Released 16 September 2009

Incorrect wiring of the STE-6013 Room Temperature Sensors

Illustration 1—Correct Wiring (Installation View)

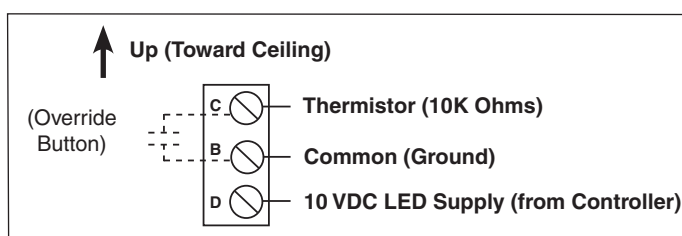
There has been confusion about the correct wiring of these sensors because of a number of factors. **The correct wiring is shown in Illustration 1.**

Whether labeled or not, **wire all STE-6013 sensors as shown in Illustration 1, with thermistor terminal C (not D) at the top** (toward the ceiling after installation). Terminal D should be at the bottom (toward the floor). (Future boards will correctly show the labels.)

Illustration 2—Board Versions

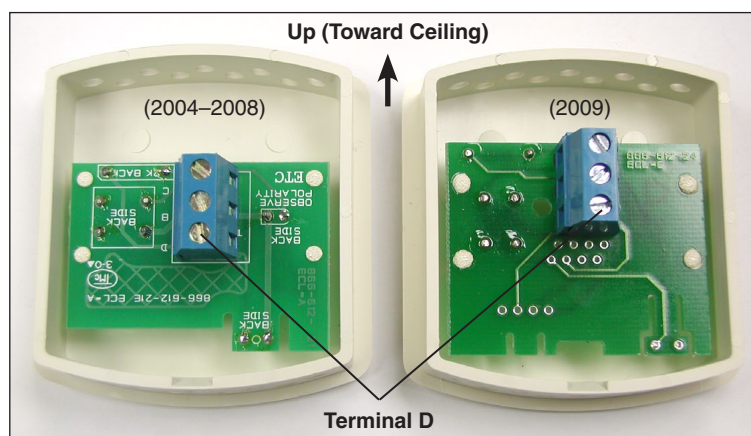
Boards for these sensors manufactured from 2004 to 2008 had the silk-screen labels “upside-down” when viewed from the installation orientation. (See Illustration 2.) Unlike most other STE-6000 series sensors, terminal D (10 VDC Supply) is toward the floor instead of toward the ceiling. In 2009, revised boards were manufactured with the terminal labels inadvertently covered by the terminal block. In installation guides before Sept. 2009, the wiring diagram showed terminal D at the top (like the other sensors). When installers wired an unlabeled top terminal as if it were terminal D, the sensor did not work.
